Bulletin No.: PIC6045

Service Bulletin

Subject: Front Seat-Mounted Speaker Buzz

Models: 2013 Cadillac XTS
Equipped with RPO UQS

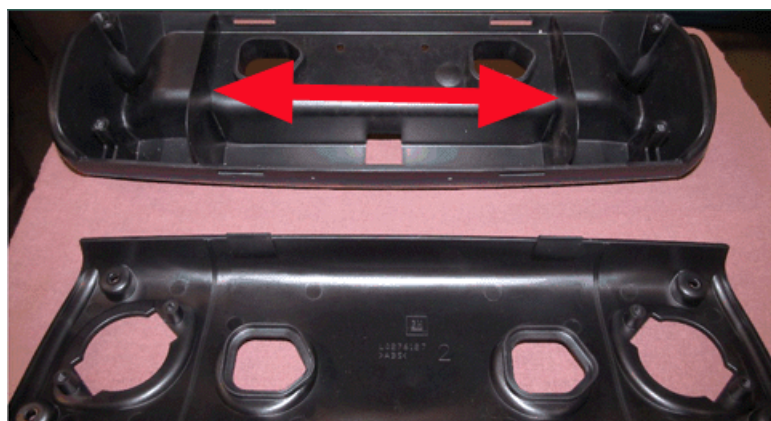
Some customers may comment that the speakers on top of the seats make a buzz noise. This concern is most likely to be evident on AM or Talk radio.

Verify Service Update 13004 has been performed first, if applicable. If this concern is still present, separate the speaker housing and apply felt tape to the raiser section as shown below.
